Rural Association of Mead Valley – Letter RAMV (2)

Re: Item 18.1 - Opposition to GPA 1151 & 1152 - Knox Business Park Building D & E Project - Final Environmental Impact Report No. 546

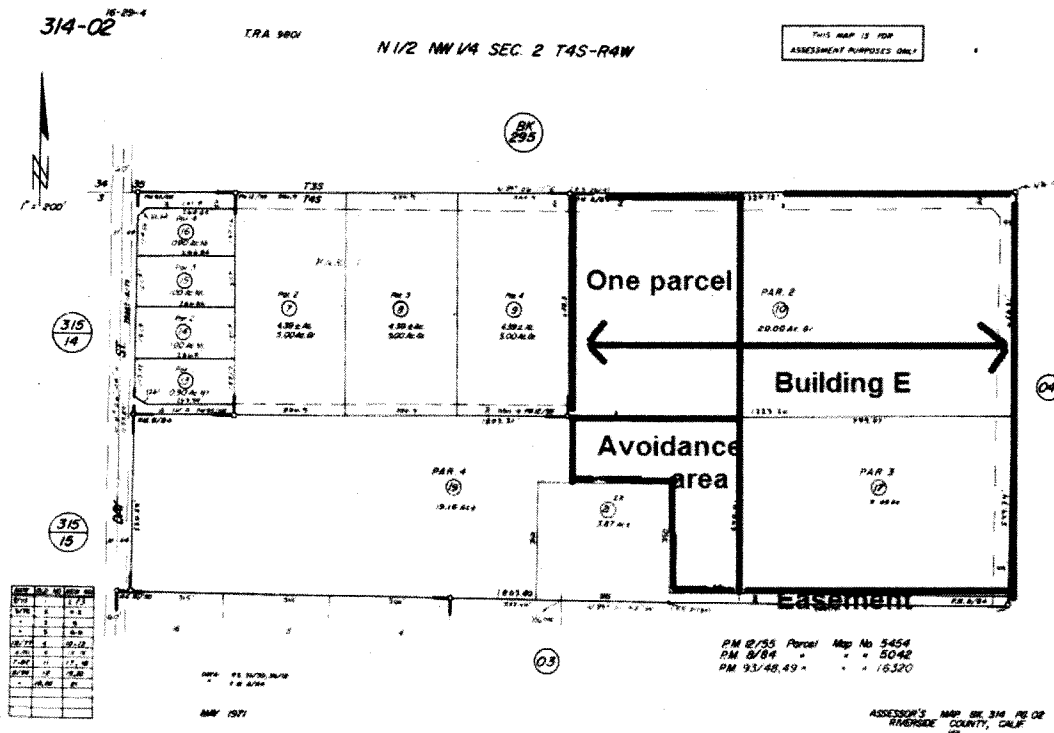
Request that Parcel Maps be removed and yet there are easements, avoidance areas and lot line adjustments that cannot be over looked. Ord. 460 requirements cannot be ignored.

RAMV (2)-6

- RAMV (2)-6 This comment makes a general statement about the Project’s conditions of approval and staff report to the Board of Supervisors and does not indicate any specific errors or omissions. The County disagrees with the commenter’s unsupported statement that there are so many errors or inconsistencies in the staff report “that makes it impossible to understand what is really being proposed.” Riverside County Ordinance No. 460 regulates the division of land. The Project will require a parcel merger for the Building D site and a lot line adjustment for the Building E site and will not require either a tract map subdivision or a parcel map subdivision as defined in Ordinance No. 460 to accomplish the respective consolidation of lots and adjustment to existing lot lines that the Tentative Parcel Maps proposed. As stated in Ordinance No. 460, Section 2.1, “General Definitions,” “Lot Line Adjustment means a minor alteration to adjust a lot line or lot lines. It is not a subdivision or re-subdivision procedure and is intended to be used only in those situations where the provisions of the Subdivision Map Act and this ordinance applicable to subdivision and re-subdivisions do not apply.”

Figure 1-1

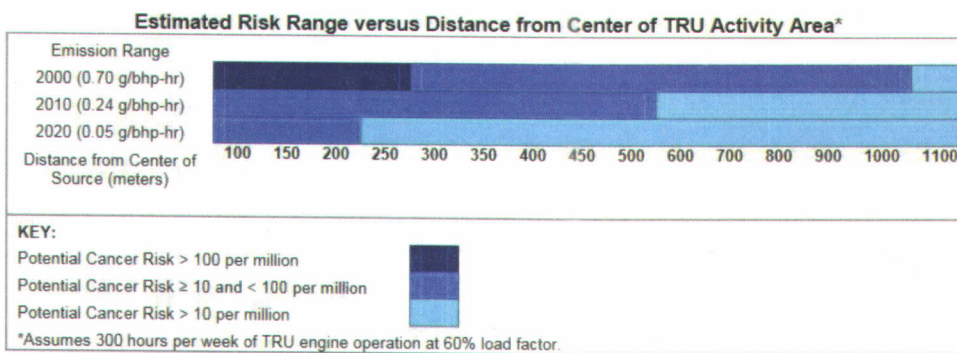
The reduction of potential cancer risk levels at locations where TRUs operate is a direct result of the reduction of diesel PM emissions. Figure 1-1 compares the cancer risk range at various distances assuming 300 hours of TRU activity per week. For year 2000, the current fleet average emission rate of 0.7 g/bhp-hr was used. In 2020, the statewide fleet PM emission rate would be reduced 92 percent from the 2000 baseline year to 0.05 g/bhp-hr. Figure 1-1 below illustrates the significant reduction of the estimated near source risk as the diesel PM emission rate is reduced from the current fleet emission rate to the much lower emission rate in 2020.⁴

RAMV (2)-22
(cont.)

- RAMV (2)-22 Refer to Response to Comment RAMV (2)-21. A condition of approval is imposed on the Project that prohibits refrigerated warehouse space; therefore, transport refrigeration units (TRUs) would not access the Project site and Figure 1-1 cited in this comment is irrelevant. As concluded by Final EIR Subsection 4.3, "Air Quality," the Project would result in less-than-significant human health risks due to diesel particulate matter.

RAMV (2)-26

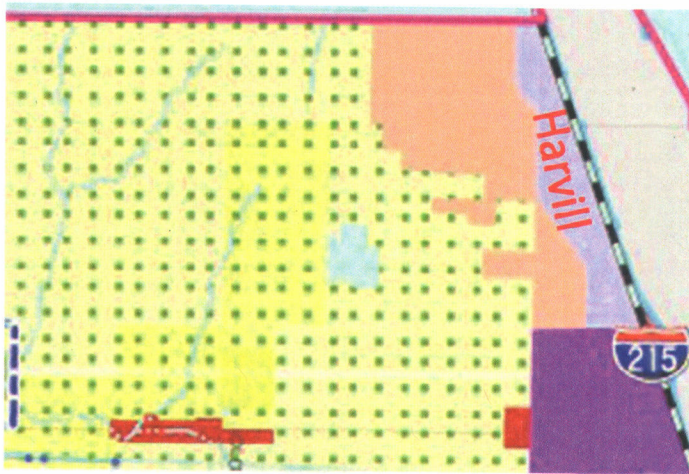
Light Industrial (LI)	0.25 - 0.60 FAR	<ul style="list-style-type: none"> Industrial and related uses including warehousing/distribution, assembly and light manufacturing, repair facilities, and supporting retail uses.
-----------------------	-----------------	--

- RAMV (2)-26 This comment is similar to FEIR Comment E-5 and the comment submitted by RAMV to the Planning Commission numbered RAMV-5; therefore, refer to FEIR Response to Comment E-5 and Response to Comment RAMV-5. Comment RAMV (2)-26 also includes a snapshot from the General Plan Land Use Map. Refer to FEIR Figure 3-4 and FEIR Figure 3-11 (FEIR pp. 3-8 and 3-17), which show that the Project site is located on land currently designated by the Riverside County General Plan as Community Development-Light Industrial (CD-LI) and Community Development-Business Park (CD-BP). The proposed Project is consistent with the General Plan's vision to develop employment-generating uses on the Project site.

EXHIBIT 1-A: LOCATION MAP

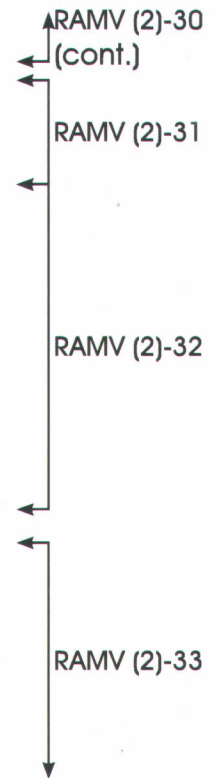
"The traffic noise levels provided in this analysis are based on the traffic forecasts found in the Knox Business Park Traffic Impact Analysis prepared by Urban Crossroads, Inc. in June 2015 (page 23). Outdated traffic report almost 3 years ago. Based on Urban Crossroads noise analysis outdated study as numerous warehouses are currently under construction along Harvill south and east of Markham as part of the Majestic Business Park. One very large warehouse was just completed north of Harley Knox x Nandina.

RAMV (2)-33
(cont.)

- RAMV (2)-33 This comment is similar to the comment submitted by RAMV to the Planning Commission numbered RAMV-12; therefore, refer to Response to Comment RAMV-12. Comment RAMV (2)-33 adds the words “x Nandina” for clarification as in, “one very large warehouse was just completed north of Harley Knox x Nandina.” This locational clarification does not require a revised response.

Harvill Ave. with trucks lined up to enter the warehouse at 17789 Harvill Ave.

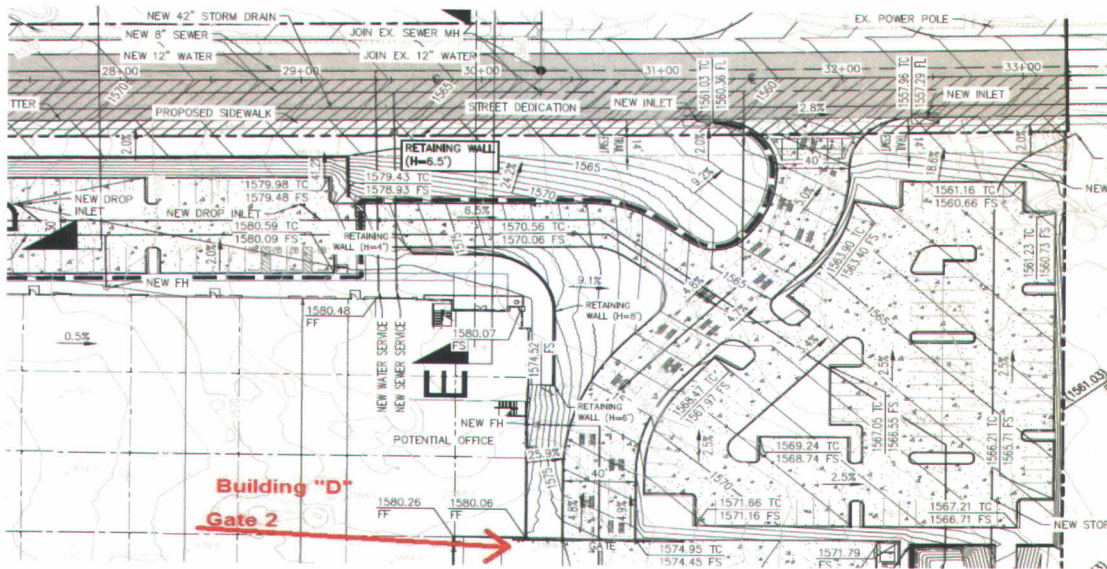
at 17789 Harvill Ave. Trucks are idling along Oleander Ave as they sleep in their trucks. EIR 546 does not adequately address the direction that trucks will enter the building or what streets they will use. All trucks must be directed to enter and exit onto Harvill Ave. from Oleander and travel to the Harley Knox Blvd overpass to access the I-215 Freeway. Logistics trucks from these warehouses must not be allowed to use our dangerous narrow rural roads. The EIR must include language that indicates all trucks use Harvill Ave. Decker Road must be closed to through traffic past the Project's southern boundary line. Closure of Decker Road must include barriers that prevent logistics trucks from accessing Decker Road past the southern boundary line of Building "D". This will allow EMWD to continue to access the road to the water tank.

RAMV (2)-90
(cont.)

- RAMV (2)-90 This comment is verbatim to FEIR Comment E-33 and verbatim to the comment submitted by RAMV to the Planning Commission numbered RAMV-69; therefore, refer to Response to Comment E-33 and Response to Comment RAMV-69.

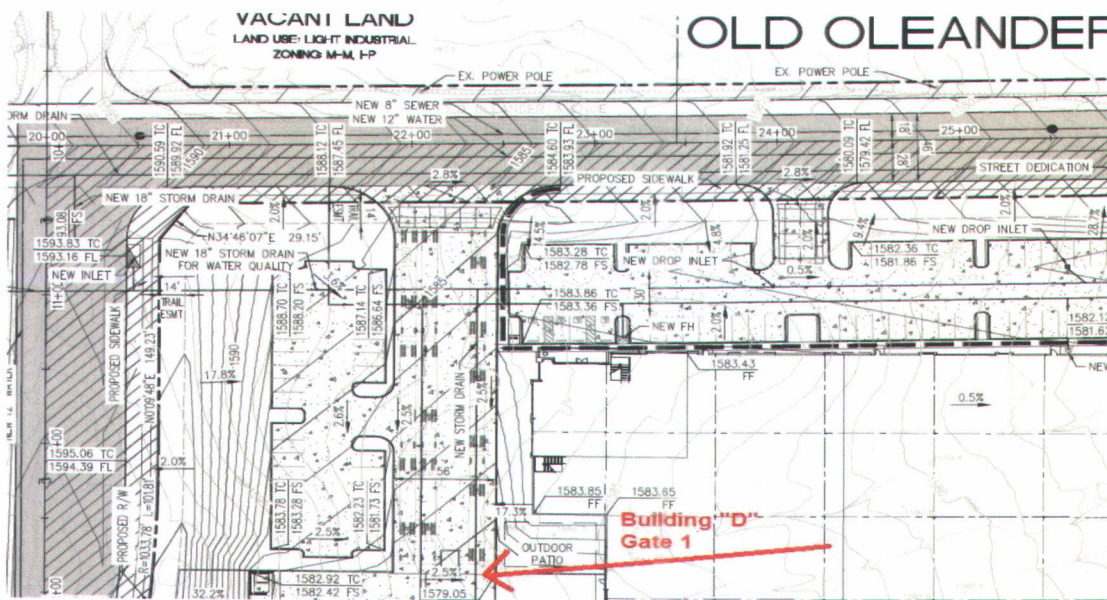
Building "D" site map dated February 24, 2017 shows the east entrance along Oleander that allows just 4 trucks to queue on site behind the gate to access the building. Knox Logistics Warehouse at 17789 Harvill Ave. shows room for 7 trucks to queue on site. In addition there is a separate lane along Harvill for trucks to access this facility. Unfortunately, this is still not sufficient safe guards as over 30 trucks are attempting to enter the warehouse at 17789 Harvill Ave. at any given time during the day. This is happening everyday all day long as trucks are idling for hours and obstructing traffic creating very hazardous conditions. Idling trucks are producing far more air pollution particulates and noxious fumes.

RAMV (2)-91

Having two gates and two separate offices one at the east side of the building and one on the west side of the building indicates that Building "D" and "E" are set up for two tenants per warehouse. This is not addressed in the EIR. Traffic studies, air quality studies, noise studies, health and safety concerns for the community are not adequately addressed in the EIR. Both Building "D" and "E" are adjacent to and very close to hundreds of rural residents.

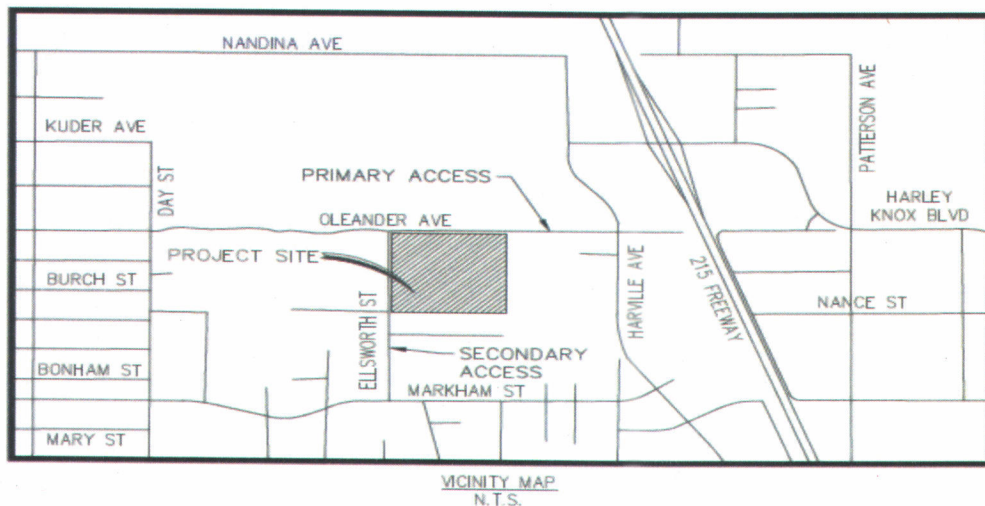
Building D showing Gate 1 that allows 6 trucks to queue on site. Trucks will be lining up traveling west on Oleander requiring trucks to turn left into Building "D" or "E" from Oleander increasing idling time as trucks wait to enter the building and turn left.
